E. NEW BUSINESS

- 8. Crane France Subdivision Addition No. 1; KPB File 2025-145
McLane Consulting Group / France
Location: Forest Lane off Sterling Highway
Sterling Area**

**ITEM #8 - PRELIMINARY PLAT
Crane-France Subdivision Addition No. 1**

KPB File No.	2025-145
Plat Committee Meeting:	May 11, 2026
Applicant / Owner:	Dan L France III / Soldotna
Surveyor:	Andrew Hamilton / McLane Consulting, Inc.
General Location:	Sterling Area – Forest Lane

CRANE-FRANCE SUBDIVISION ADDITION
 NO. 1
 A SUBDIVISION OF TRACT A CRANE-FRANCE SUBDIVISION (KN2022-083)

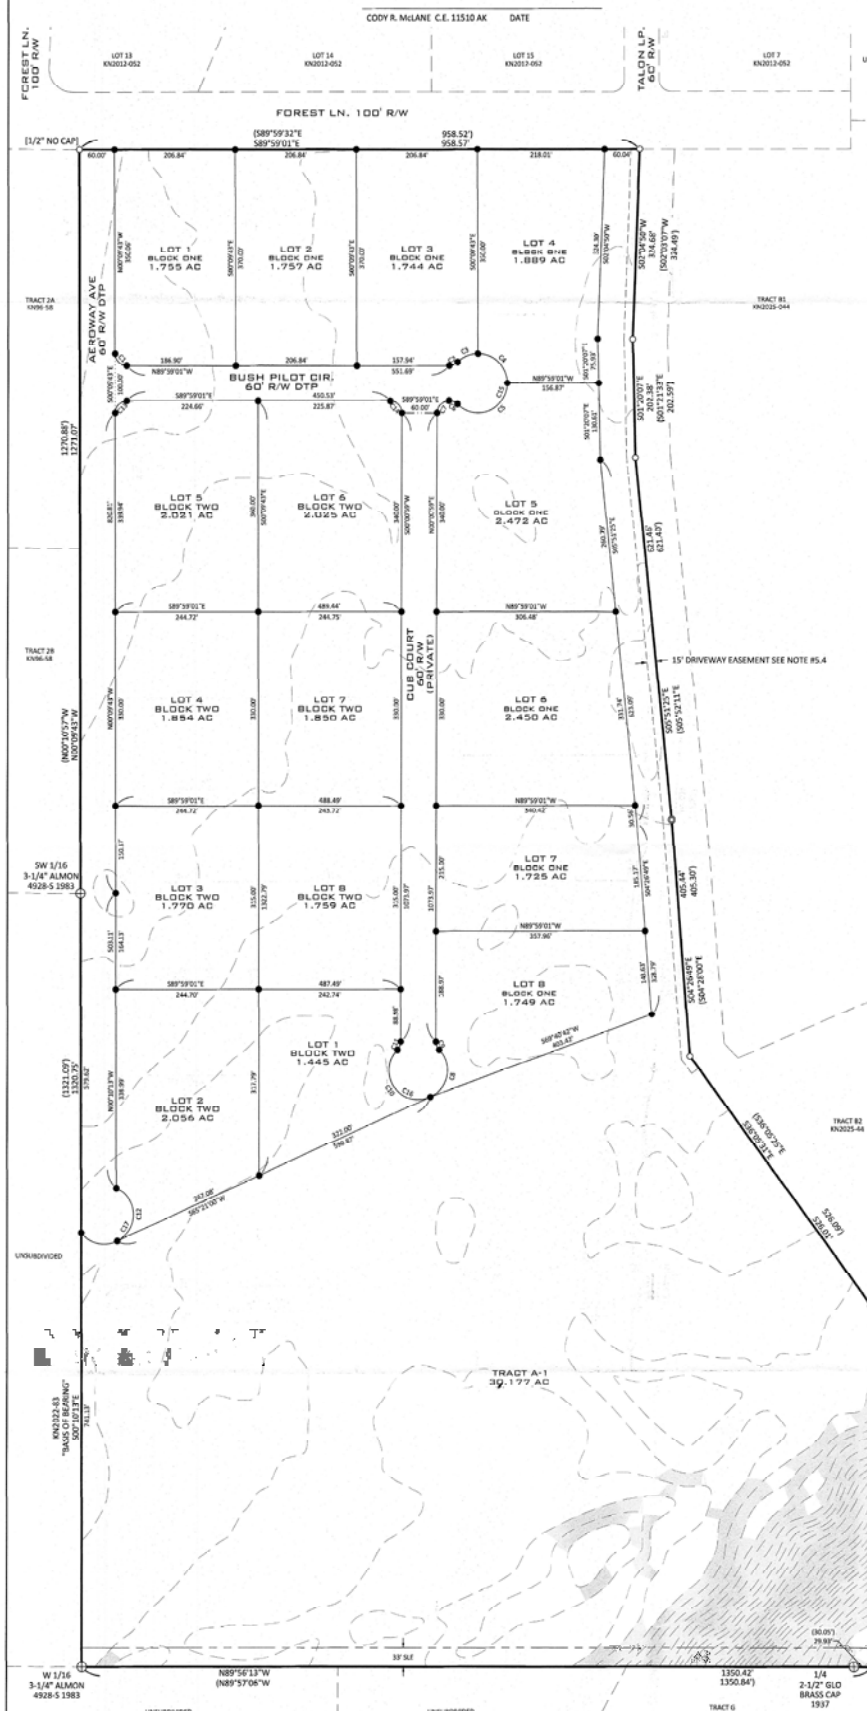
There is a 33-foot section line easement located on the south side of the proposed plat. **Staff recommends** a plat note in reference to item 9 of the Certificate to Plat be added and tied to the section line easement noted on the drawing.

There is a reciprocal easement agreement noted on the drawing and referenced to plat note 5.4. the easement document identifies it as being 30' wide, while the drawing shows the 15 feet on the side of this plat. **Staff recommends** the surveyor note that the easement is 15' on both sides of the property line for 30' total.

Block length is not on the west side of Block 2 along Aeroway Ave. From the center of Bush Pilot Cir south to the center of the bulb, the length is approximately 1420' being 100' longer than the required 1320' and longer than the

limit of no more than 1000'. The applicant has requested an exception to KPB 20.30.100(A) Cul-de-sacs and KPB 20.30.170 Block-length requirements. These will be looked at later in the staff report.

There are steep areas over 20% indicated on the plat, being located in the south east corner of the subdivision. The steep slopes are labeled with a hatched to it.

Plat note 10 needs carried forward to this plat. This note is in direct relation to the request from HEA for the easement over the overhead power line.

Add to the Plat Approval the date of October 13, 2025

Wastewater Disposal note for lots 1-8 Blocks 1 & 2 needs to match recommendation from engineer.

Check the information on the BLM pins, other sources indicate years and other data given on caps

Modify the KPB File No. to 2025-145

Plat notes and sub-notes as aligned are congested and confusing to read, please adjust.

- D. A vicinity map, drawn to scale showing location of proposed subdivision, north arrow if different from plat orientation, township and range, section lines, roads, political boundaries, and prominent natural and manmade features, such as shorelines or streams;
Staff recommendation:
 Foster Ln needs changes Forest Ln. near the top.

- F. The location, width and name of existing and platted streets and public ways, railroad rights-of-way, easements, and travel ways existing and proposed, within the subdivision;
Staff recommendation:
 Add a plat note for the section line easement noted at item 9 of the CTP and tie to notation on the drawing, this would be related to parent plat note 10.
 Add a plat note for item 10 of the CTP
